CONTRACT CHANGE ORDER

CCO: 11	Suppl. No. 0	Contract No. 04 - 0120F4	Road SF-80-13.2/13.9	FED. AID LOC.:
---------	--------------	--------------------------	----------------------	----------------

Incorporate the following changes into the Project Plan Sheets:

P-1

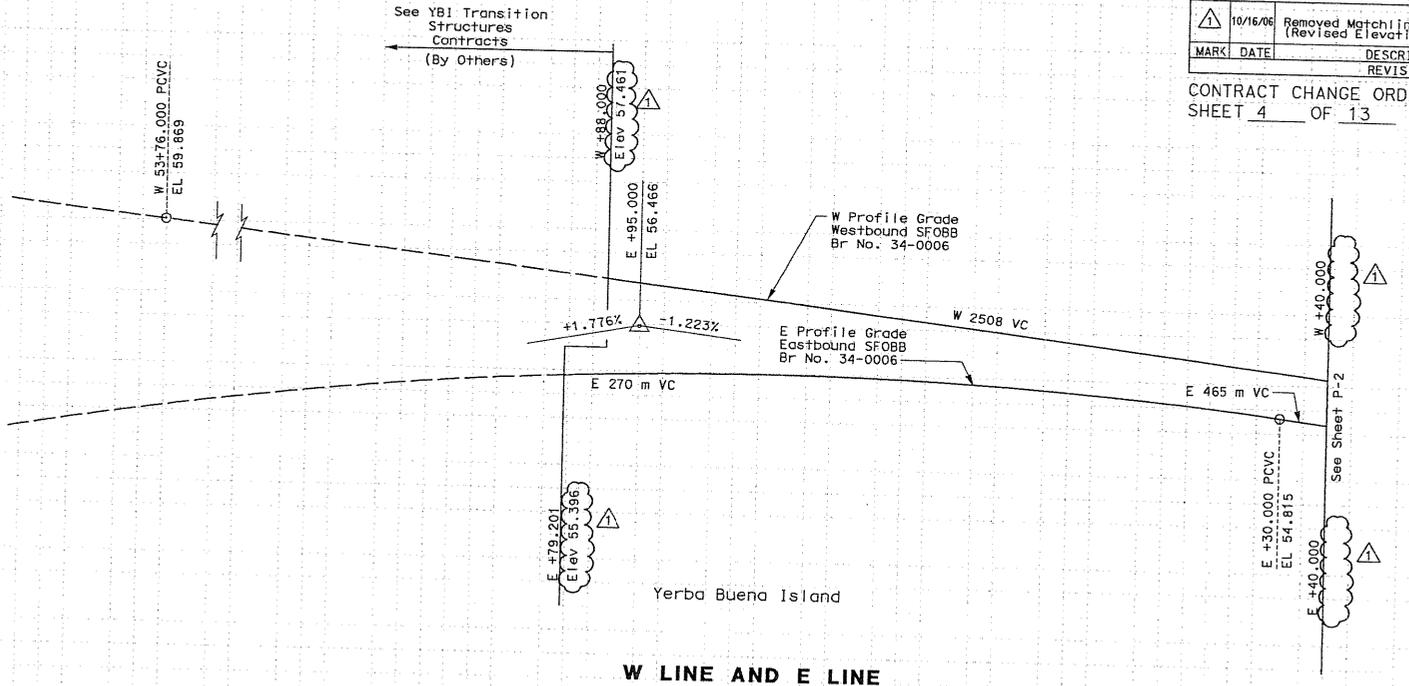
1. Revise Project Plan Sheet Numbers 5, 6, and 7 of 1204, as shown on sheets 4, 5 and 6 of this change order.
2. Revise Plan sheet numbers 97, 98, and 99 of 1204 (E-14, E-15, and E-16) to reflect revised electrical manhole elevations, as shown on sheets 7, 8 and 9 of this change order.
3. On plan sheet number 132 of 1204: SHEET NOTE 5 should reference "Sheet No. 965 of 1204" instead of "Sheet No. 934 of 1161", as shown on sheet 10 of this change order.
4. On plan sheet numbers 133 and 208 of 1204: SHEET NOTE 3 should reference "Sheet No. 965 of 1204" instead of "Sheet No. 934 of 1161", as shown on sheets 11 and 12 of this change order.
5. On Project plan sheet number 233 of 1204: Revise electrical notation number 3 to read : "Ground cable shall be installed along full length of the 15 KV cable tray only", as shown on sheets 13 of this change order.

10/16/06	Removed Matchline Elevations (Revised Elevations)	LR	MG	11
MARK	DATE	DESCRIPTIONS	REV	CK
		REVISIONS	CCO	NO.

P-2

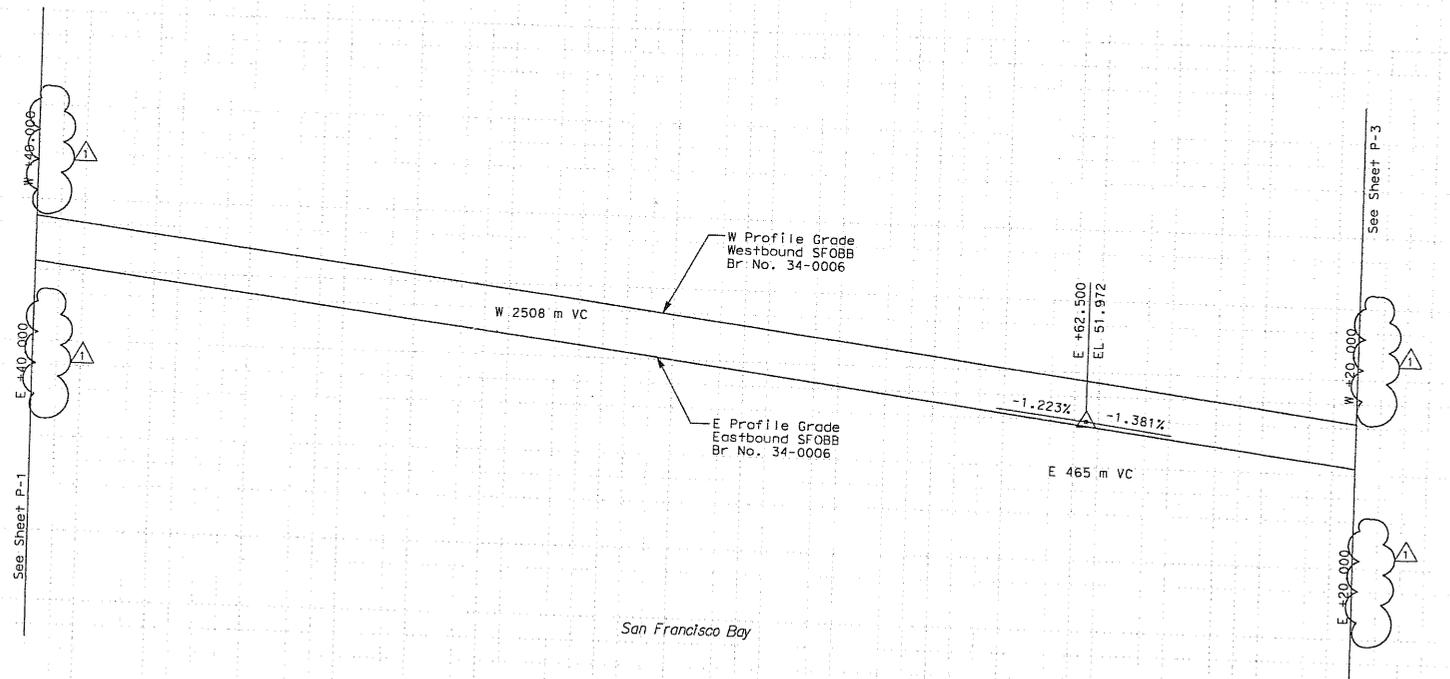
10/16/06	Removed Matchline Elevations	LR	MG	11	
MARK	DATE	DESCRIPTIONS	REV	CK	CCO NO.
		REVISIONS

P-3

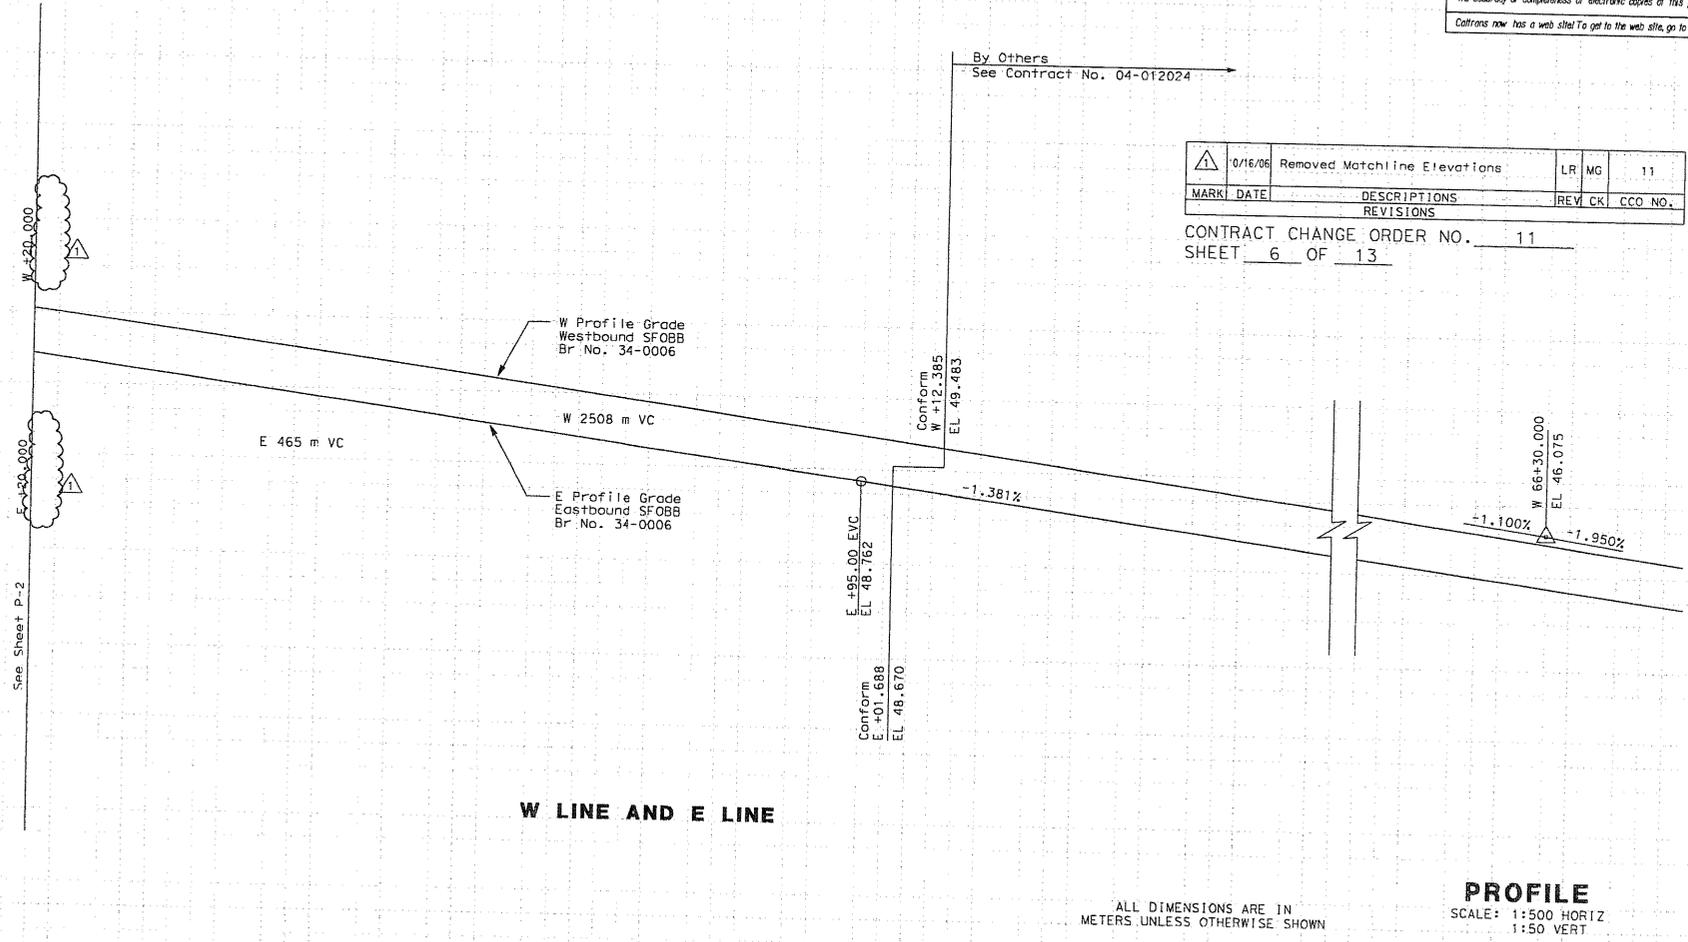
0/16/06	Removed Matchline Elevations	LR	MG	11	
MARK	DATE	DESCRIPTIONS	REV	CK	CCO NO.
REVISIONS

PLAN-MANHOLE-25
 SCALE: 1:20 (600 V)

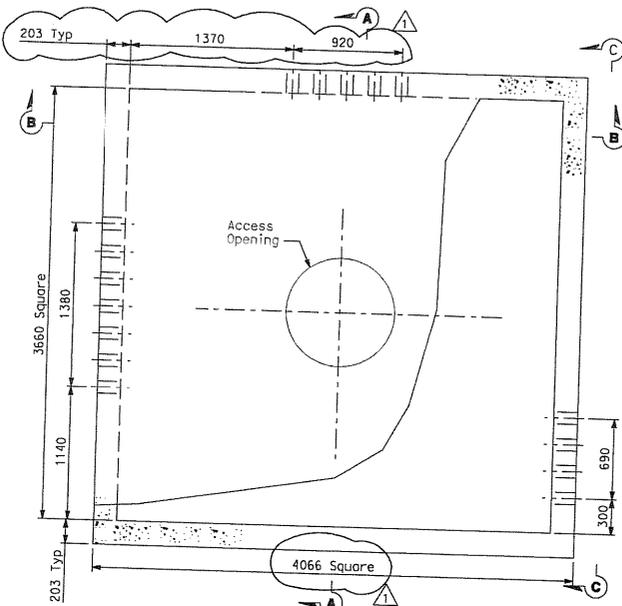
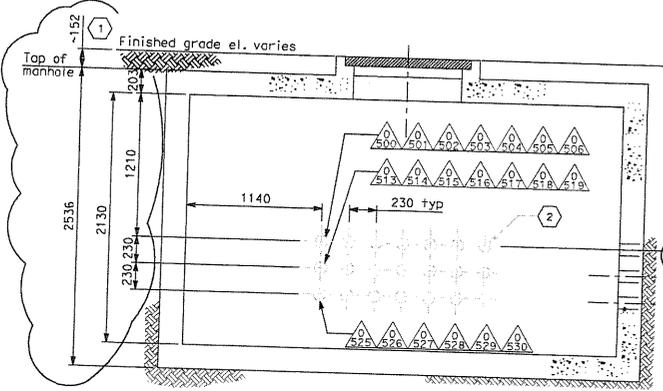
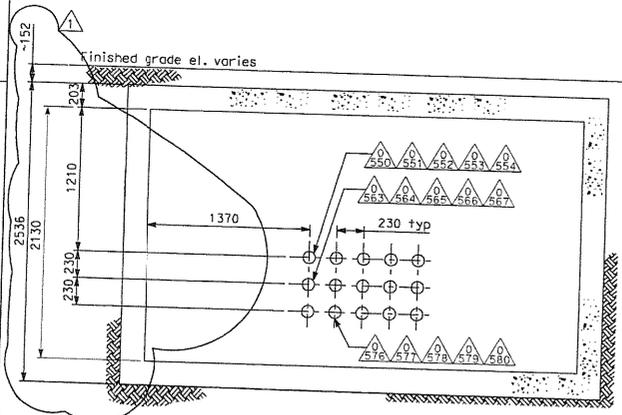
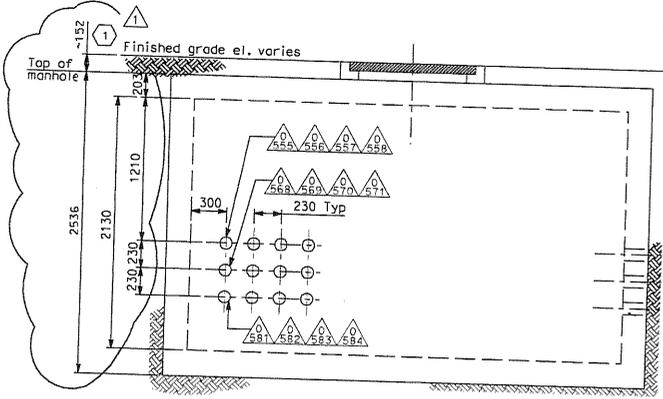
MARK	DATE	DESCRIPTIONS REVISIONS	REV	CK	CCO NO.
1	1/10/06	Revised Manhole detail	CR	JE	11

PLAN-MANHOLE-26
 SCALE: 1:20 (12.47 kV)

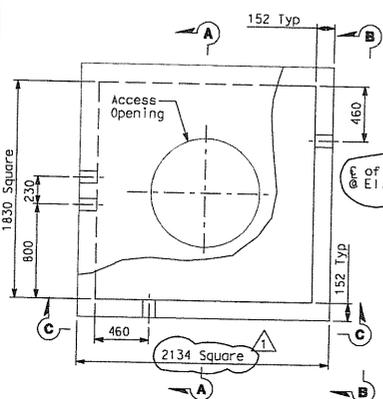
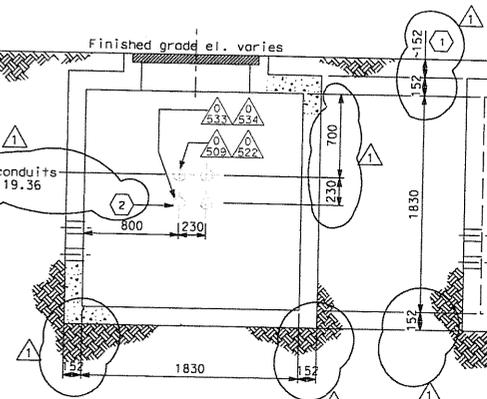
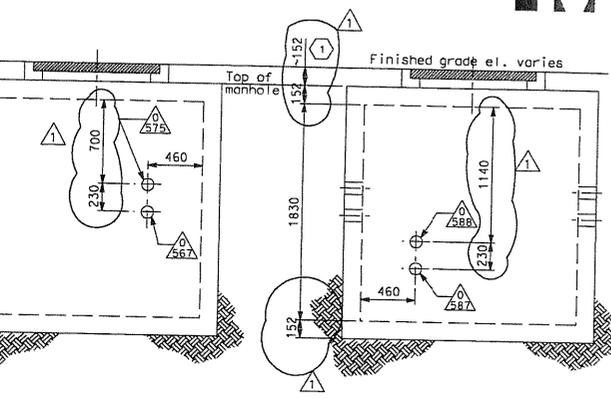
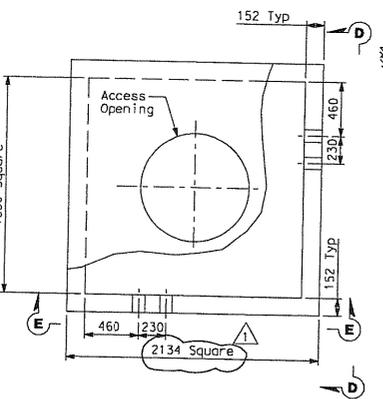
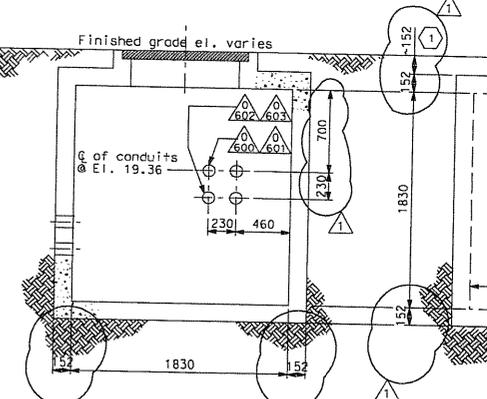
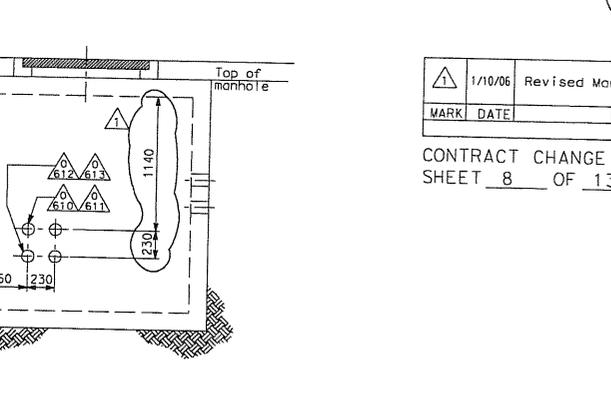
1/10/06	Revised Manhole detail	CR	JE	11	
MARK	DATE	DESCRIPTIONS	REV	CK	CCO NO.
		REVISIONS

PLAN-MANHOLE-27
 SCALE: 1:20 (TOS & COMMUNICATION)

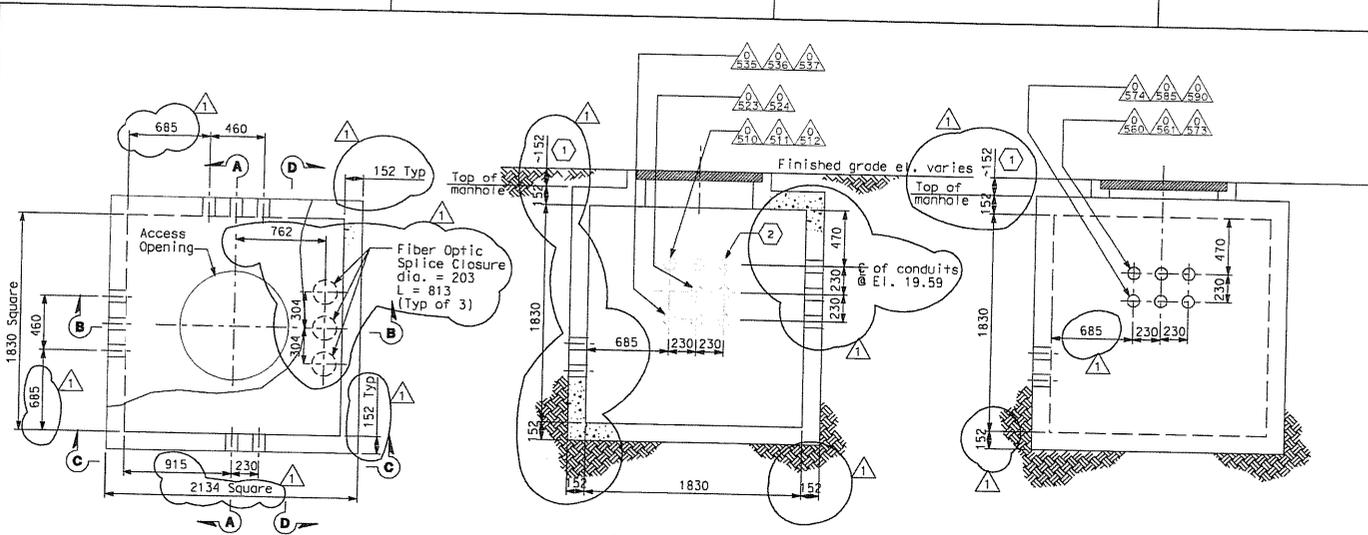
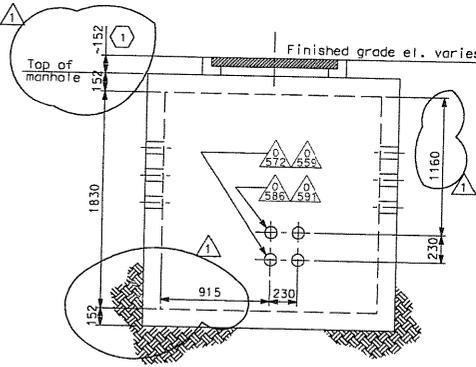
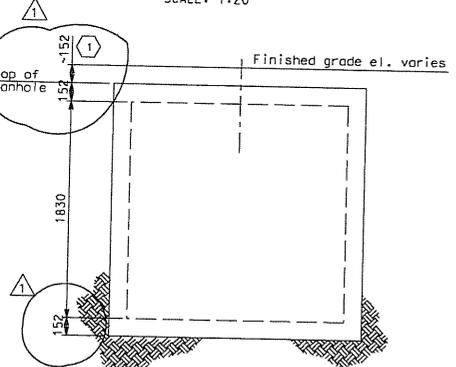
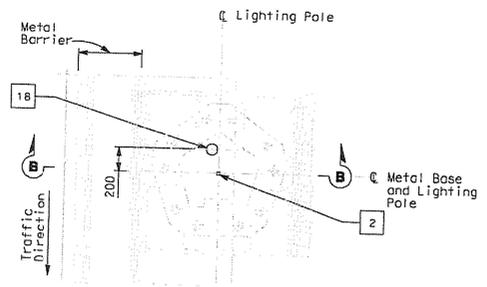
(1)	1/10/06	Revised Manhole detail	CR	JE	11
MARK	DATE	DESCRIPTIONS	REV	CK	CCO NO.
REVISIONS

DETAILS
SAS SUPERSTRUCTURE ROADWAY WESTBOUND
CONDUIT LOCATIONS
 SCALE AS NOTED

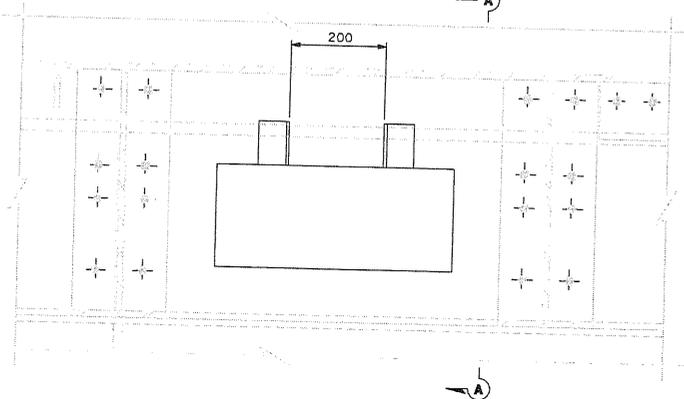
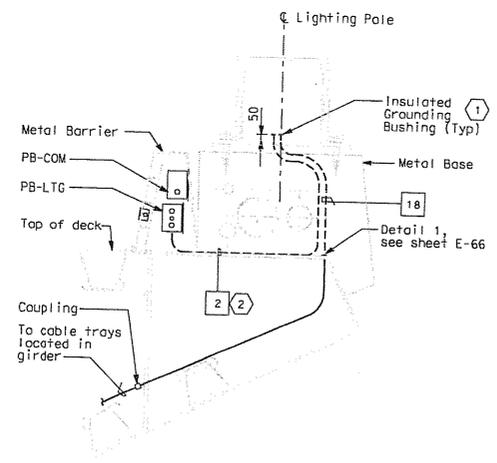
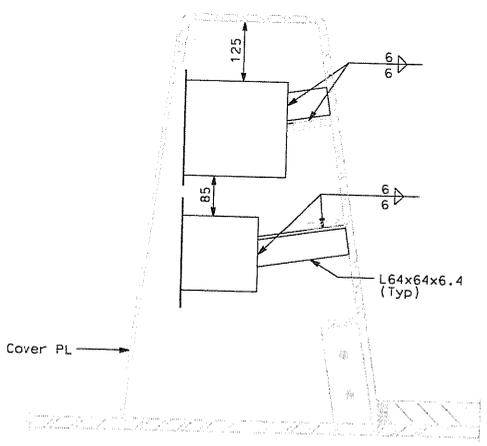
10/16/06	Revised sheet notes.	LR	MG	11	
MARK	DATE	DESCRIPTIONS	REV	CK	CCO NO.
REVISIONS

- 1 Bond grounding bushing to ground lug of lighting pole or overhead sign post with #6 bare copper wire.
- 2 Conduit shall clear all piping and pipe sleeves. Route conduit on top of deck plate, outside of girder box.
- 3 See Utility Detail No. 1 (Sheet No. 965 of 1204) for conduit penetration through girder plate and lighting pole metal base. The Contractor shall install sealant between the sleeve and conduit to prevent water or moisture from passing inside the sleeve.

DETAILS
SAS SUPERSTRUCTURE GIRDER EASTBOUND
TYPICAL CABLE TRAY AND GROUNDING INSTALLATION 2
 SCALE AS NOTED

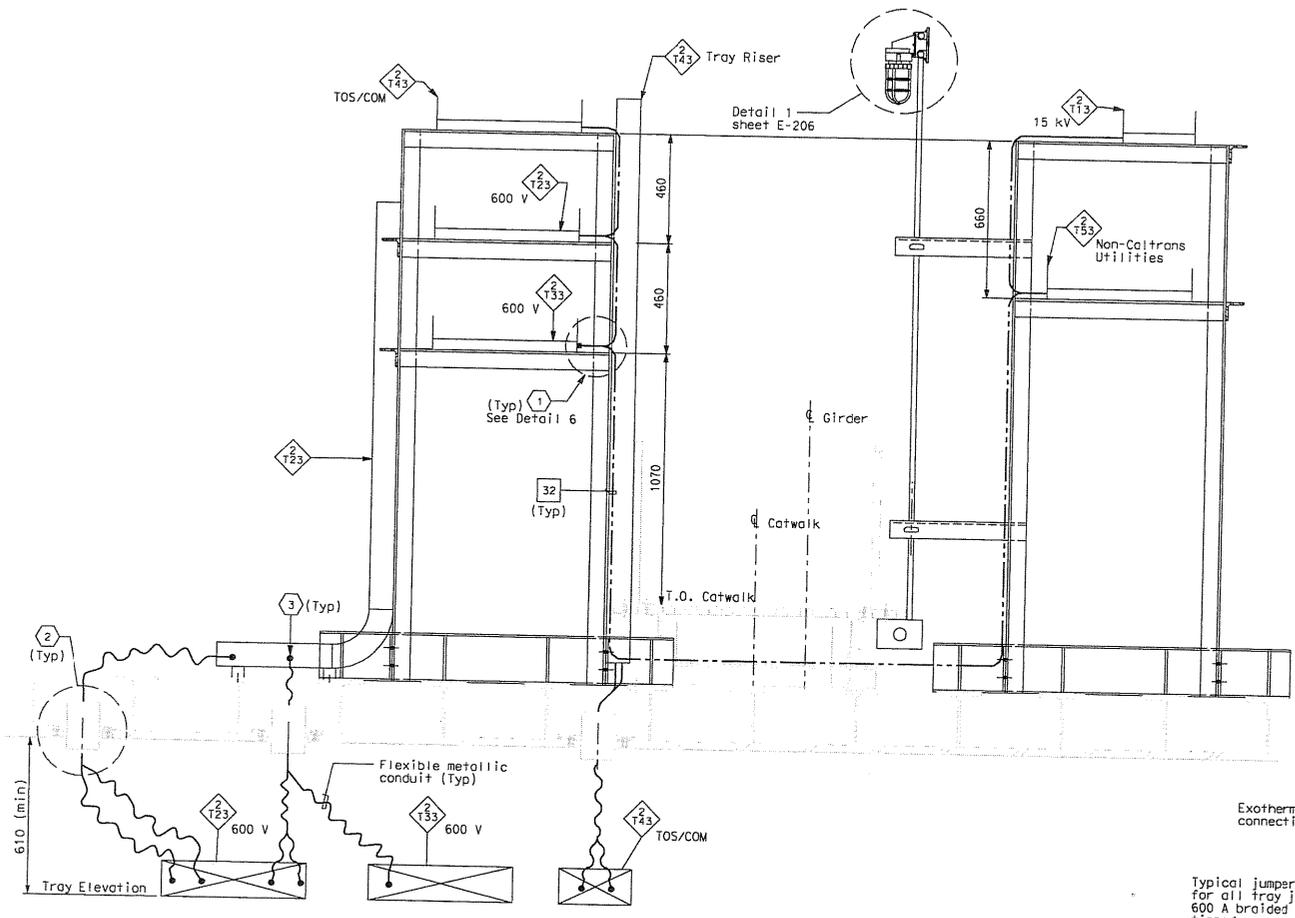
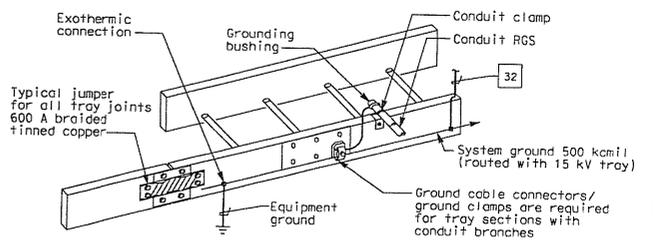
1	1/10/06	Revised note. Bidder Inquiry #330.	CR	JE	11
MARK	DATE	DESCRIPTIONS	REV	CK	CCO NO.
REVISIONS

- NOTES:**
1. See structural drawings for Catwalk Support Details.
 2. For SAS Superstructure Girder access detail #2, see structural dwgs.
 3. Ground cable shall be installed along full length of the 15 kV cable tray only.
 4. For typical cable tray support details, see AS-sheets.
